AMENDMENT OF SOLICITATION/MODIFICATION OF CONTRACT			1. CONTRACT ID CODE	PAGE 1 OF 4 PAGES
2. AMENDMENT/MODIFICATION NO. AMENDMENT NO. 0005		3. EFFECTIVE DATE 07/12/10	4. REQUISITION/PURCHASE REQ. NO.	5. PROJECT NO. (If applicable) 09-0205
6. ISSUED BY CODE		CODE	7. ADMINISTERED BY (If other than Item 6) CODE	
Officer in Charge of Construction MCI-East 1005 Michael Road Camp Lejeune, NC 28547-2521			See Item 6	
8. NAME AND ADDRESS OF CONTRACTOR (No., street, county, State and ZIP Code)			(X)	9A. AMENDMENT OF SOLICITATION NO. N40085-09-R-0205
			X	9B. DATED (SEE ITEM 11) 06/25/10
				10A. MODIFICATION OF CONTRACT/ORDER NO.
				10B. DATED (SEE ITEM 11)
CODE	FACILITY CODE

09-0205, Renovations of Galley, Building NH100

WALL DETAIL

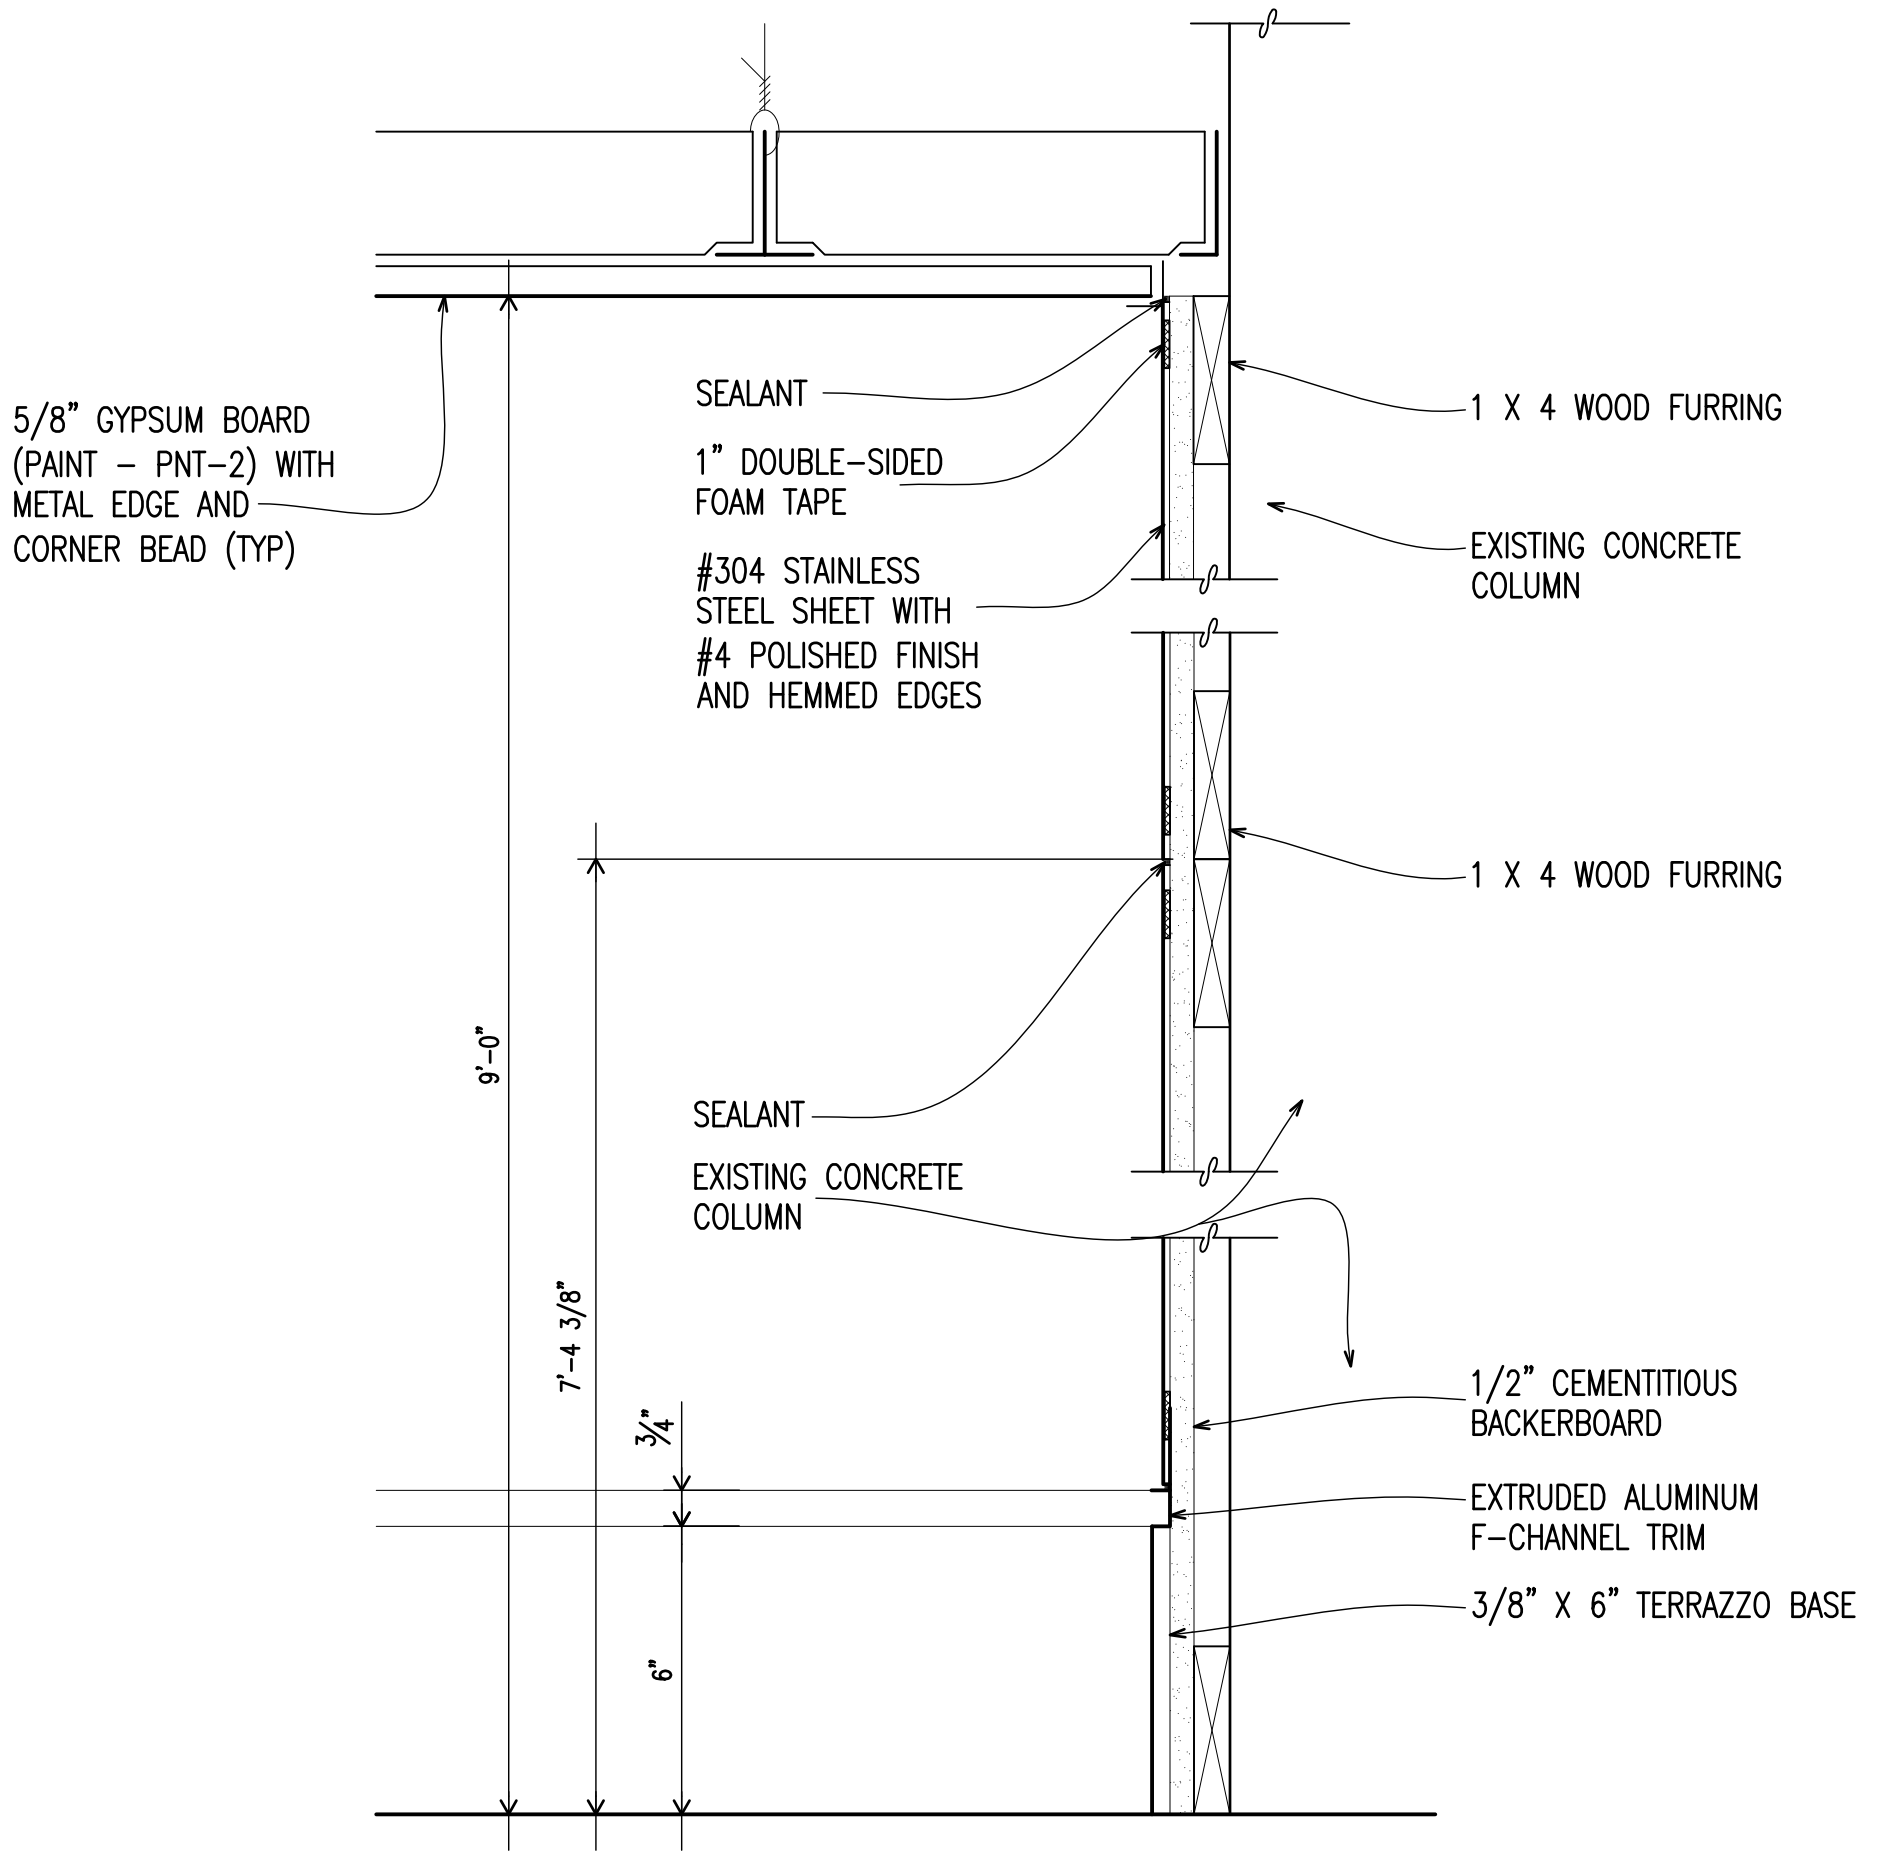
Delete details 3/A-502, 9/A-502, and 1/A-503. Replace them with the attached details of the corresponding numbers.

In details 2/A-502, 4/A-502, 6/A-502, 7/A-502, 8/A-502, 10/A-502 delete the Stainless Steel Composite Column Covers (Stainless Steel Composite Panels). These details are to be constructed similarly to the new details provided in this amendment (3/A-502, 9/A-502, and 1/A-503). Provide ½” cementitious backer board and 20 gauge #304 stainless steel sheet with #4 polished finish and hemmed edges in lieu of Stainless Steel Composite Panels.
